JRPP No:	2012SYE051
DA No:	DA 136/12
PROPOSED DEVELOPMENT:	621 Pacific Highway, St Leonards Demolition of existing 11 storey commercial building and construction of 17-18 storey mixed use development
APPLICANT:	Bill Paterson
REPORT BY:	George Youhanna, Executive Planner North Sydney Council

Assessment Report and Recommendation

Pre-Lodgement Meeting Plan of Ground Level

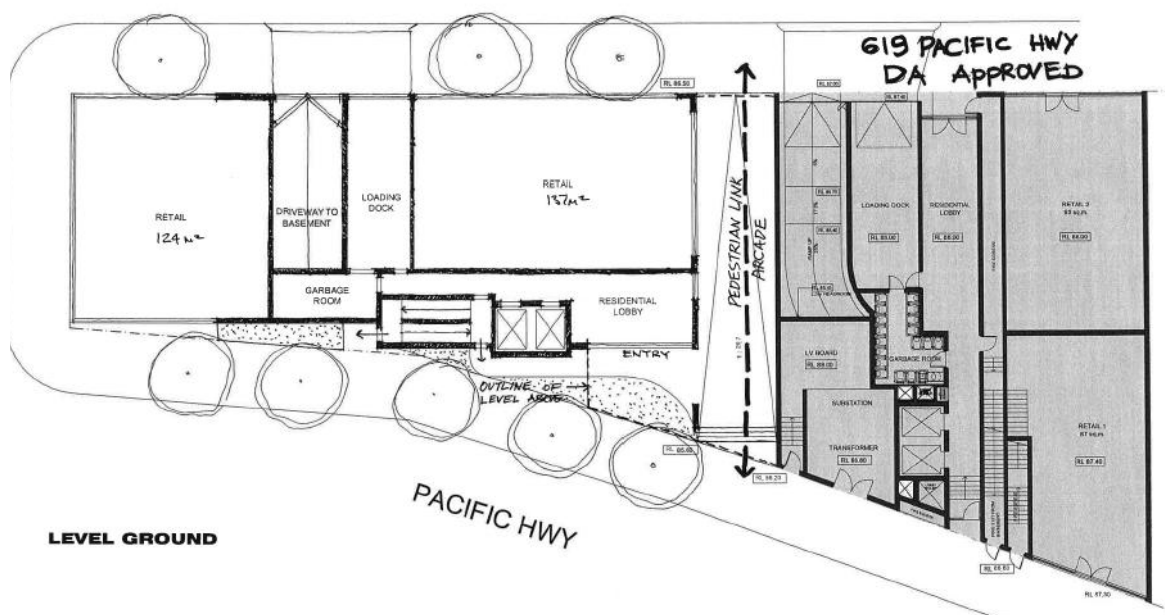
On 22 November a pre-lodgement meeting for redevelopment of the site was held involving the proponents and Council staff. The development proposed was a 19 storey mixed use building, with 30 serviced apartments and 90 residential units. The key issues identified with the proposal were as follows:

- *The Draft LEP seeks to rezone the site from mixed use to commercial. It is not known at this time if or when the draft LEP will be gazetted and it may need to be re-exhibited and/or amended. On this basis, the Draft LEP is considered not to be "certain or imminent".*
- *The set backs at ground level should be increased for improved pedestrian amenity. Concern was raised in relation to the proliferation of loading bays and driveways to Atchison Street. Site consolidation with No.619 Pacific Highway is the preferred outcome, particularly given that both sites will potentially be redeveloped concurrently. A consolidated development would have particular benefits in relation to the Atchison Street ground level design, and would avoid the need for two driveways, loading docks, etc, while increasing the proportion of*

active street front usage to Atchison Street. It would also facilitate an improved basement parking configuration, allowing conventional ramps to be constructed rather than mechanical stackers and car lifts.

- *The draft St Leonards study would require a ground level set back of 3 mtrs from the Pacific Highway.*
- *The present height is excessive and unacceptable as it is significantly over the height limit in the Draft LEP, and would need a planning proposal to vary the current 49m height limit under North Sydney Local Environmental Plan 2001.*
- *The possibility of increasing the building height based on the provision of a tangible public benefit at the lower levels was briefly discussed. While no specifics were tabled, it was acknowledged that a ground or podium level public open space would be a desirable feature of any redevelopment of the site. The open space would ideally be oriented to the north and shielded from traffic noise from Pacific Highway to provide an acceptable level of user amenity.*
